AP1000 DESIGN CERTIFICATION REVIEW

Draft Safety Evaluation Report Open Item Response

DSER Open Item Number: 3.7.2.9-1 (Revision 1)

Original RAI Number(s): 230.020

Figure 3.7.2.9-1-1: Node 532 – FRS comparison - Y Direction

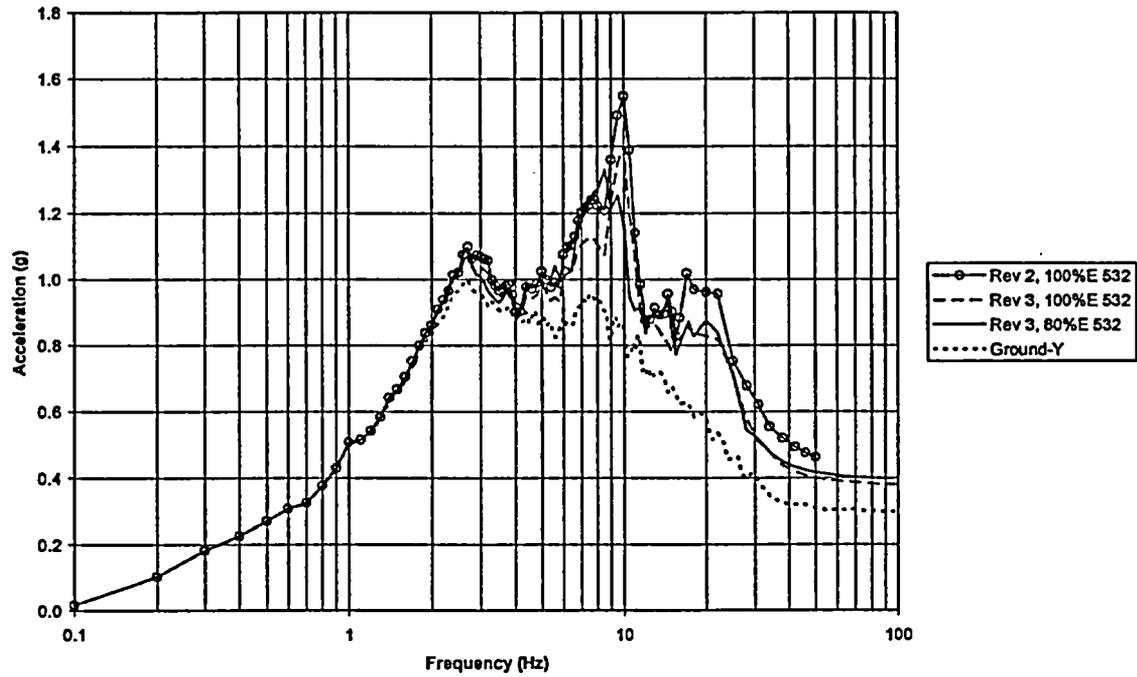
As described in DCD Tier 2 Section 3.7.2.9, as part of accounting for parameter uncertainty, Westinghouse in its response to DSER Open Item 3.7.2.3-1 shows floor response spectra which include the effects of stiffness reduction due to shear wall concrete cracking. In comparing the floor response spectra published in DCD Revision 3 which was based on uncracked concrete properties (100% E), and DCD Revision 6 which is based on partially cracked concrete properties (80% E), it is found that in most instances the 80% E analysis, shows increases in floor response spectra peaks. There are a few instances however where the floor spectra peaks have been reduced. Examples of this are the floor response spectra in the EW (Y) direction of the containment internal structures nodes 532 and 535. The staff would like Westinghouse to cite the reasons that can explain the change in the reduction at these two locations.

Figures 3.7.2.9-1-1 and 3.7.2.9-1-2 show the floor response spectra in the EW (Y) direction of the containment internal structures nodes 532 and 535. The differences between the Rev 2 100% E spectra and the Rev 3 100 %E spectra are due to a more accurate representation of the nuclear island model (including the SCV being attached to the CIS). This more accurate representation included smaller masses at these locations as well as new beam properties based on the CIS finite element model stiffness analyses. The differences between the Rev 3 100% E spectra and the Rev 3 80 %E spectra are due to change from uncracked to partially cracked concrete properties. The reduced stiffness changes cause slight changes in the nuclear island mode shapes that reduce the response in this location.
